**Subject:** Virgil C. Summer Nuclear Station (VCSNS) Units 2 and 3  
Docket Numbers 52-027 and 52-028  
Response to Requests for Additional Information related to Preservice Inspection  
Requirements for Steam Generator Nozzle to Reactor Coolant Pump Casing  
Welds Rev. 1

- Enclosure 1: Virgil C. Summer Nuclear Station (VCSNS) Units 2 and 3 – Response to NRC Staff Request for Additional Information (RAI) Regarding Preservice Inspection Requirements for Steam Generator Nozzle to Reactor Coolant Pump Casing Welds Rev. 1

**Response to Request for Additional Information #1 – LTR-PAFM-16-59-NP, NRC RAI Response  
Regarding Inspection of *AP1000* Vogtle Units 3 & 4 and V.C. Summer Units 2 & 3 Steam  
Generator to Reactor Coolant Pump Suction Nozzle Weld (Non-Proprietary) Rev. 1**

Figure 2: Crack Growth Chart for the *AP1000* Steam Generator to Reactor Coolant Pump Suction Nozzle  
Dissimilar Metal Weld, Outside Surface Axial Flaw with Aspect Ratio = 2

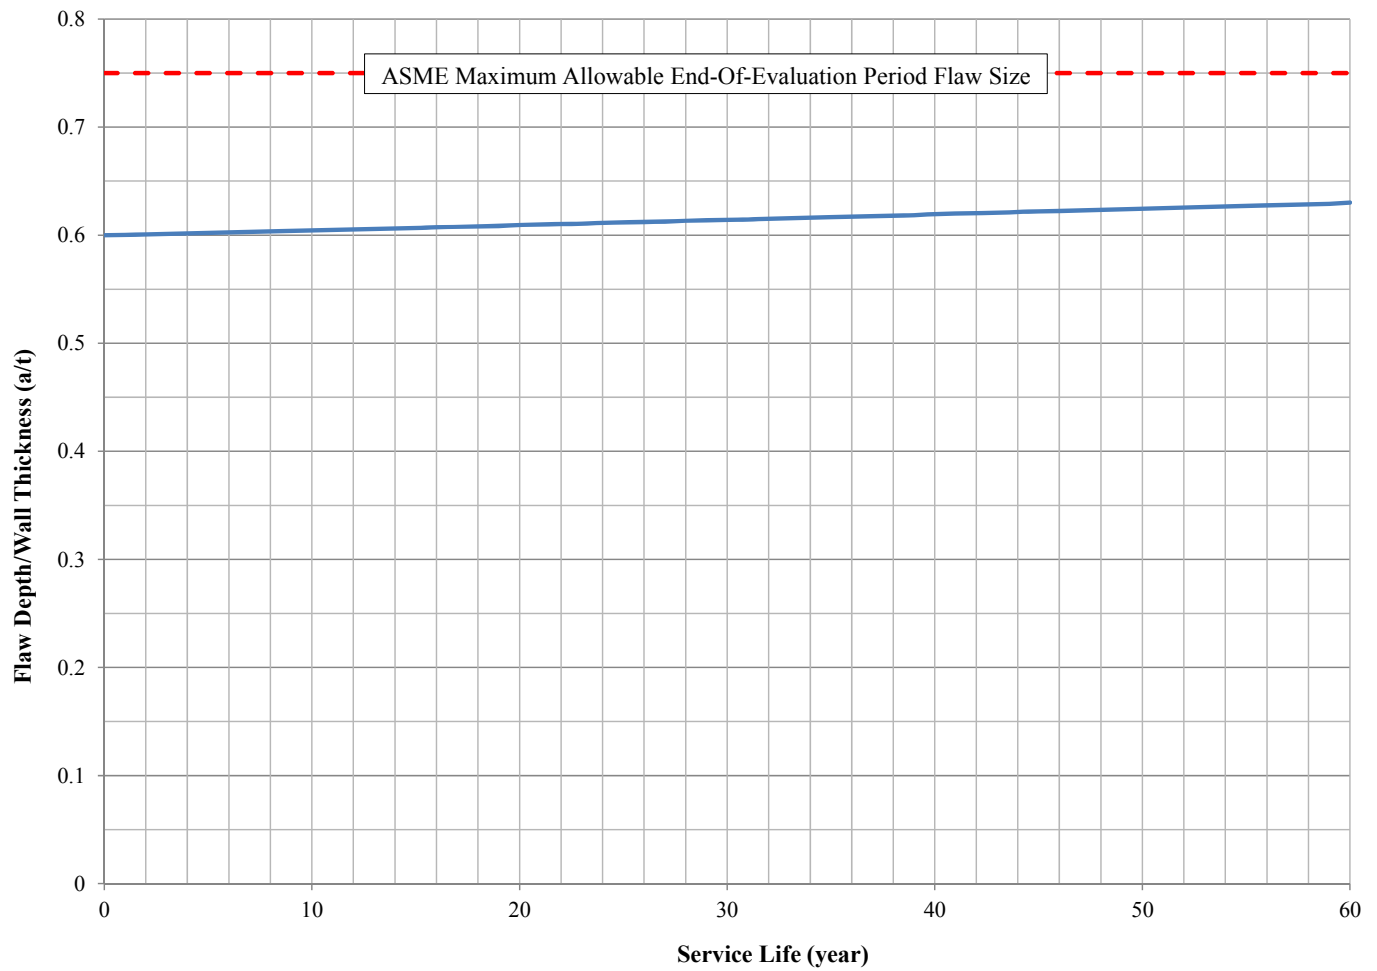
To resolve this issue, the staff requests that the licensee provide additional information or analyses to justify why the proposed examinations are an acceptable alternative to examining the full weld volume. Specifically, the staff requests that the licensee, at a minimum, provide an analysis which considers the size and nature of the largest potential defect which could be expected to be present in the outer 2/3 of the weld as well as the operating loads to which the weld will be subject for the licensed lifetime of the facility. To support the requested alternative, this analysis would be expected to demonstrate that the initiation of active degradation of the weld would not be expected to occur from the postulated defect in the outer 2/3 of the weld over the licensed lifetime of the facility.

As shown in Figure 2 for an axial flaw, even a 60 percent through the wall thickness flaw would not reach the maximum allowable flaw size in 60 years. Figure 3 for circumferential flaws shows that a postulated flaw as large as 30 percent through the wall thickness flaw would not reach the maximum allowable flaw size in 60 years. Any initial axial and circumferential flaw sizes less than the 60 and 30 percent of the wall thickness, respectively, are encompassed by these curves and will not grow to the maximum allowable flaw size in 60 years. The large axial and circumferential surface flaw sizes described above do not exist in the eight (8) DM welds of Vogtle Units 3 and 4, and six (6) of the eight (8) DM welds of V.C. Summer Units 2 and 3 as evidenced by the ASME Section III fabrication PT examination results. The remaining two (2) DM welds in V.C. Summer Unit 3 will not contain surface flaws as described above given the allowable standards of ASME Code Section III, NB-5000. Surface flaws will be detected by the regular ISI surface examinations of the outside surface of the SG to RCP suction nozzle DM weld.
